TECHNICAL INFORMATION LETTER

TIL N° T-139-22-001

SUBJECT: Tail Rotor Drive Line (TRDL) bearing support panel reinforcement

Helicopters Affected: AW139 helicopters

Figure 1

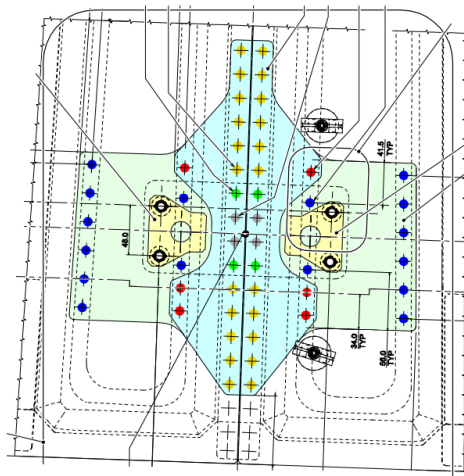
▪ Tail Rotor Drive Retromod P/N 3G5350P00311

This retromod allows the installation of doublers and shims on the upper side of right and left tail panels (Figure 1) and it is composed by:

- ✓ a basic design applicable to structures not already repaired;
- ✓ specific part to adapt the retromod to the existing repairs performed in-service in the affected area, if present.

Figure 2

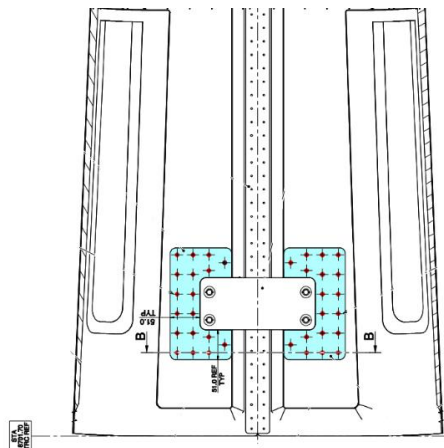
▪ Tail Rotor Drive Internal Side Retromod P/N 3G5350P00611

This retromod allows the installation of two doublers on the lower side of right and left tail panels (Figure 2) and is equivalent to the existing repairs performed in-service in the affected area.
